Staff Report

To: Salt Lake City Planning Commission
From: Krissy Gilmore, Senior Planner
Kristina.Gilmore@slcgov.com, 801-455-6714
Date: June 12, 2024
Re: Modifications to Design Review Approval for Lotus Alchemy (PLNPCM2022-00422)

Design Review Modification

PERMIT: *Lotus Alchemy, BLD2022-09228; 48 W 700 S*
SUBJECT: *MINOR MODIFICATIONS*

Proposed Level 2 Floor Plan

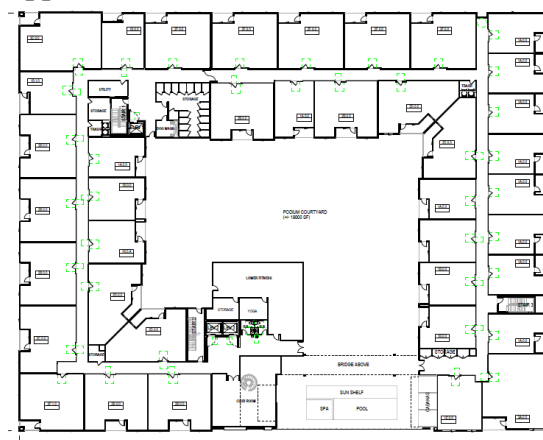
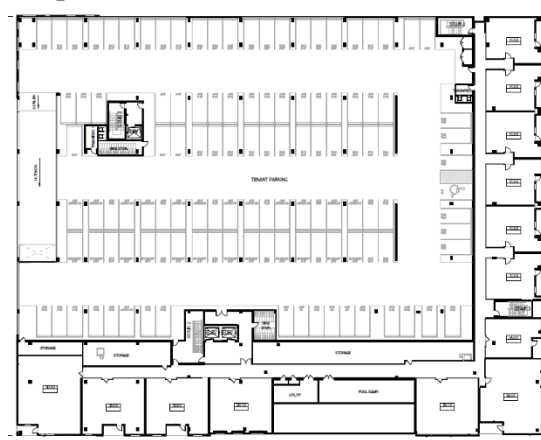
The approved building design originally included five wood construction levels over two concrete podium levels, with an underground level. Due to budget constraints, the applicant is now proposing to remove the underground parking level and construct a building with 4 wood levels over 2 concrete levels, all above grade. Essentially, the ground level will stay the same, but the second level has been modified to include parking. To maintain the same building height, 30 units have been removed and the parking count decreased to 229 spaces.

Most changes to the building are internal, keeping the original public facing building design largely the same. Since level two now includes parking, this results in slightly taller metal screening on the second level above the parking garage entrance. Additionally, the east and rear facades, which do not face the street, now include screened openings on the second level.

The second level floor plans are provided below to help inform the changes made to the exterior of the building:

Proposed 700 South Elevation

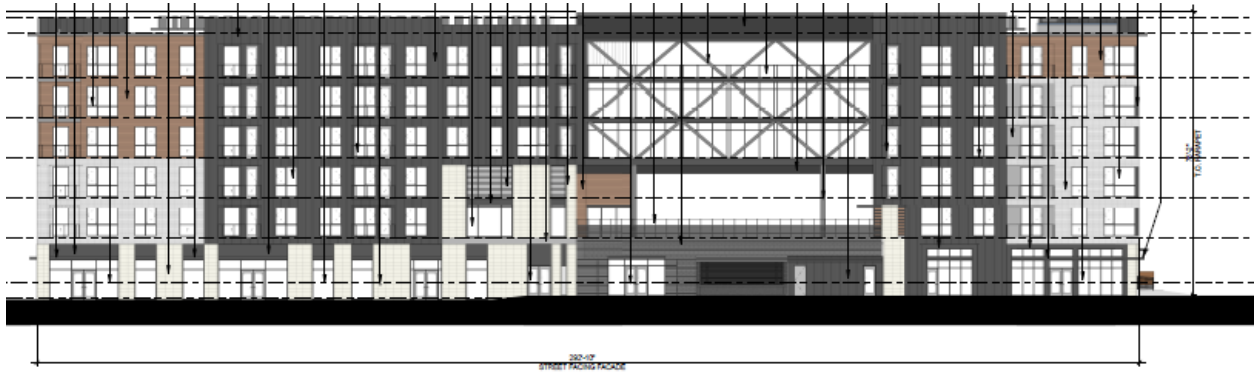
Primary changes include a taller screening above the parking garage and below the amenity deck and minor changes to color and materials above the ground floor windows.

Proposed East/Midblock Walkway Elevation

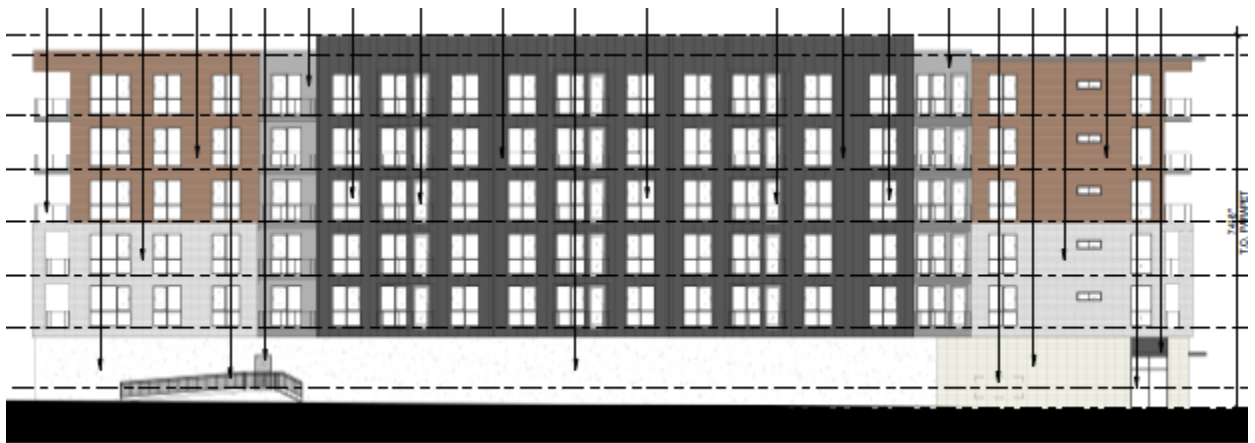
Changes include carrying the light stone veneer to the second level and carrying the wood tone fiber cement siding down on the north side of the building. Some minor window changes were also made.

Proposed North Elevation:

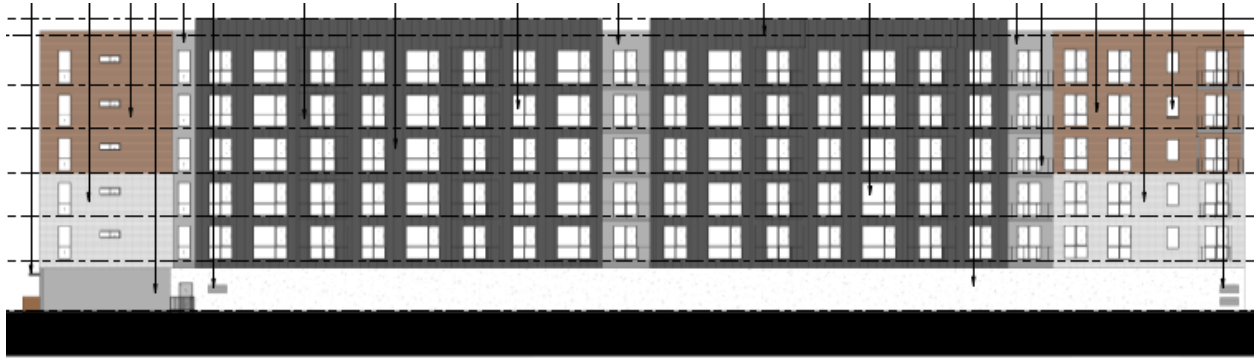
Similarly, the north elevation was modified to accommodate the internal second level parking. It now includes perforate metal screening, additional stone veneer, and additional windows on the ground level.

OVERALL SECOND FLOOR PLAN

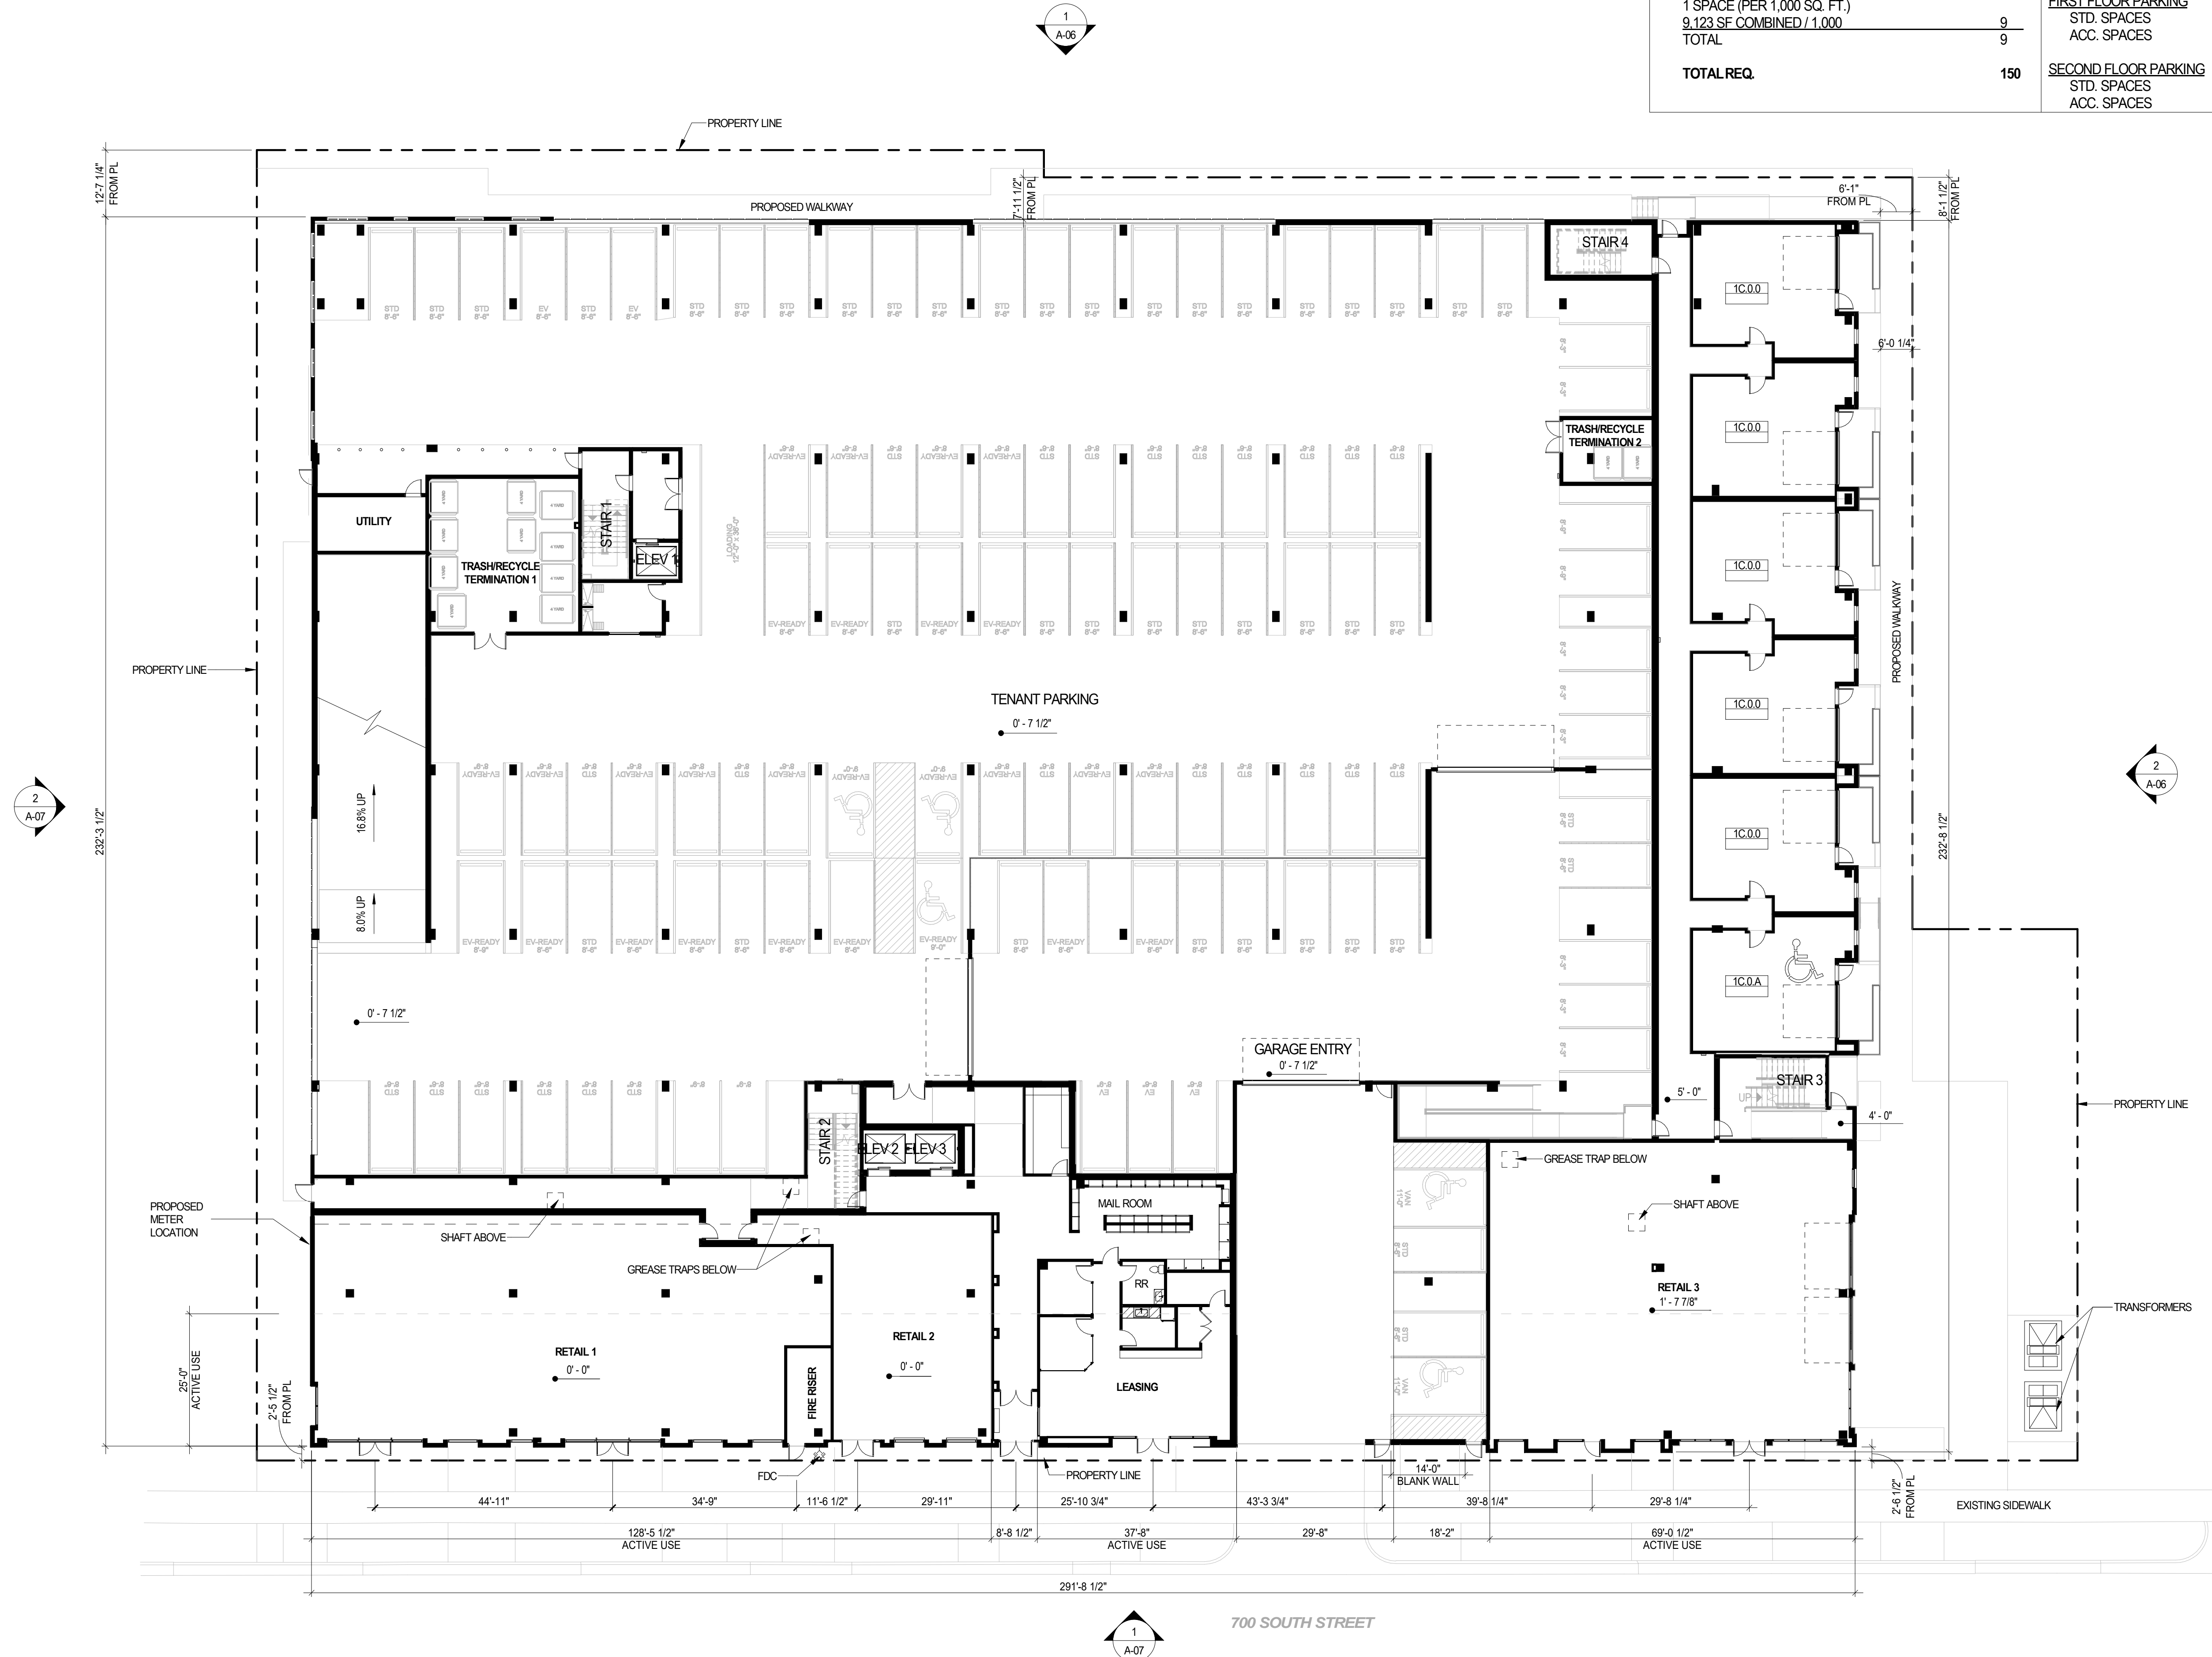
The objective is to keep as much of the approved design intact, and to preserve the essence of the design intent. The Unit Count is projected to be reduced by 30 units, and the parking count will drop accordingly to maintain the approved parking ratio for a total of 229 parking spaces. The reduction of residential units resulted from eliminating the 43 top floor units and adding 13 units to Level 2 on the South and West facades to hide the parking garage from the active use elevations – like the commercial retail spaces on Level 1. The building footprint and site design shall not change, and all street level active uses remain with commercial and retail space along the south street façade, as well as the units along the west mid-block walkway façade. Because the parking garage is now completely above ground, it can be naturally ventilated with screened openings along the west and north façades. We feel this revised design still meets the intent of the base design typology with these added screened openings. The building still interacts with the site and engages its surroundings with the same intent as the previously approved design. Please refer to the provided planning documents which include floor plans of Levels 1 & 2, as well as elevations demonstrating these updates.

Please note that because the building is now raised all above grade, the previously approved Level 2 plan is now Level 3, and so on for all levels above Level 3. The design of these plans has not changed and the unit layout remains the same as the previously approved plans.
